## SYDNEY WESTERN CITY PLANNING PANEL

**REPORT:** DRAFT SWCPP Report

**FILE No:** DA 384.1/2021  
PAN-138481  
PPSSWC-221

<b>Property:</b>	Lot 37 in DP202006, Lot 39 in DP202006, Lot 136 in DP16186, Lot 381 in DP1232437 and Lot 382 in DP1232437 at No. 2 Kamira Court, Villawood (Total of five (5) lots).
<b>Application lodged</b>	21 October 2021
<b>Applicant</b>	Adam Byrnes (Think Planners)
<b>Owner</b>	NSW Land and Housing Corporation
<b>Application No.</b>	DA 384.1/2021
<b>NSW Planning Portal Application No.</b>	PAN-138481
<b>Planning Panel Reference No.</b>	PPSSWC-221
<b>Proposed Development</b>	Stage 1 of the Redevelopment of No. 2 Kamira Court within the Villawood Town Centre, involving Tree Removal, Construction of a 8-10 Storey Mixed Use Development comprising Information and Education facility with ancillary Cafe on the ground floor, 112 Residential Units, Public Open Space, a Podium Car Park comprising 119 Car Parking Spaces, associated Road Works and Landscaping pursuant to the State Environmental Planning Policy (Affordable Rental Housing) 2009.

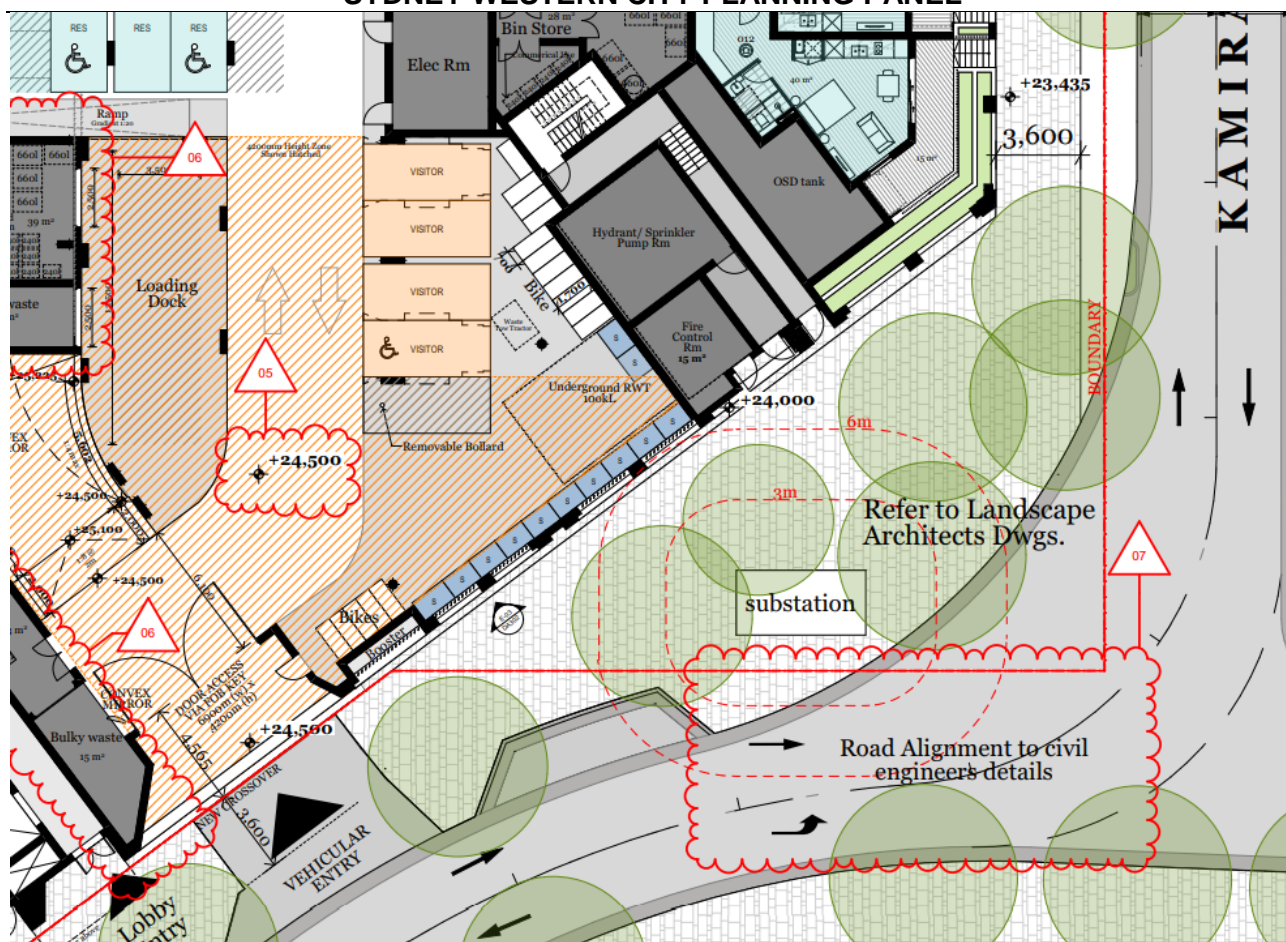
It is noted that the northern setback on Level 4 does not comply with the setback requirements in the ADG. The proposed setback is 15.2m, the ADG requires 18m. Given that this is a greenfield development, Council considers that the non-compliance is not appropriate and compliance is necessary to protect the privacy of future residents, instead of a design solution.

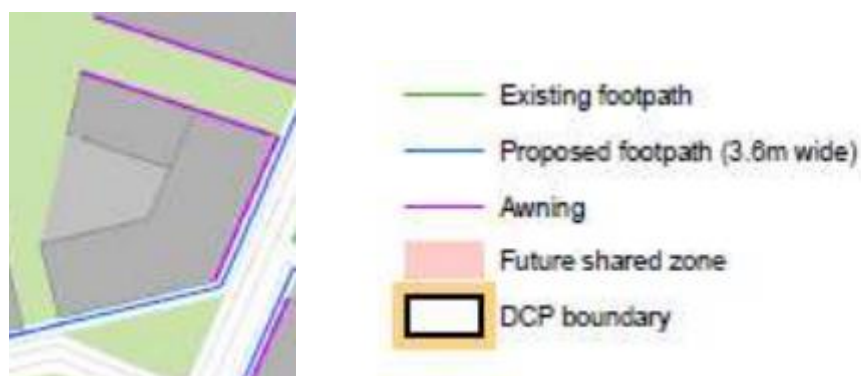
The Amended Urban Design Study refer to the creation of a pocket park at the corner of Kamira Avenue and Howett Street. As outlined above, the peer review that was undertaken supported the introduction of this and recommended that non residential uses address the park given the commercial uses that would face this park from the adjoining approved Mixed Use development at No. 47 Pedestrian Mall. In support of this recommendation the Draft DCP acknowledges this and therefore seeks an active street frontage to this park. This is depicted in the figure below:

The proposal has been designed with limited active uses facing the Pocket park with most of the Back of House and services addressing it. Furthermore, the proposal seeks to construct a substation within the park instead of within the built form which is inconsistent with all the other recent Mixed use Developments within Villawood Town Centre.

Given the lack of an active edge to the pocket park, the proposal is inconsistent with the Awning Plan indicated in the Draft DCP which
